TECHNICAL SERVICE BULLETIN

REF.: ACCESSORIES
NO.: AX003-96
DATE: AUGUST 30, 1996
MODEL: 4RN

Title: '96 4RUNNER HOOD PROTECTOR WHISTLING NOISE CONCERN Page 1 of 2

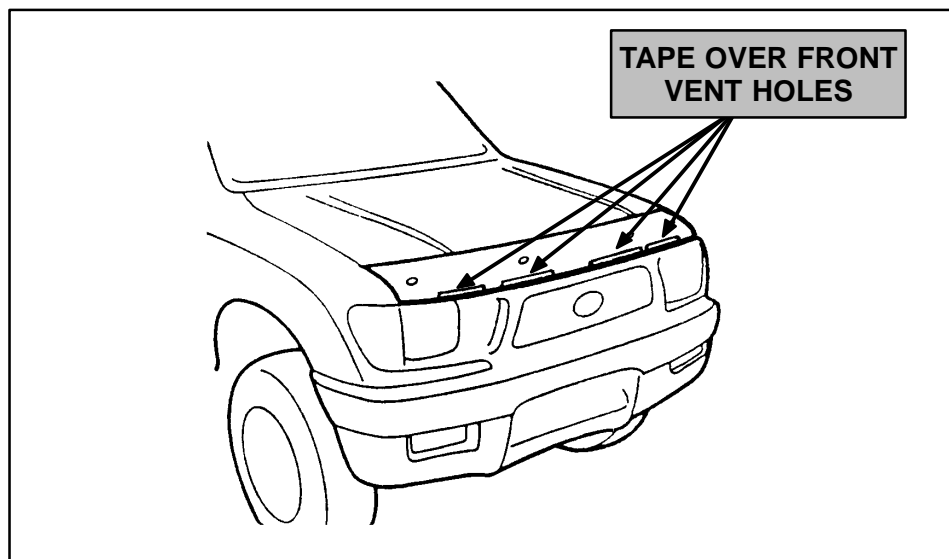
There is a potential whistling noise on 1996 4Runners with hood protectors (P/N 00500-89960) which is caused by the size of the front air slots on the hood protector. To eliminate this whistling noise, hood protectors manufactured after March 12, 1996 have been modified.

To verify the exact cause of the whistling noise on the 1996 4Runner with hood protectors, cover the front air slots with masking tape and test drive the vehicle at highway speeds.

If the whistling noise is still present, check for other possible causes of noise.

If the whistling noise is eliminated, replace the current hood protector with a new part, manufactured after March 12, 1996. Please use the normal warranty claim procedures.
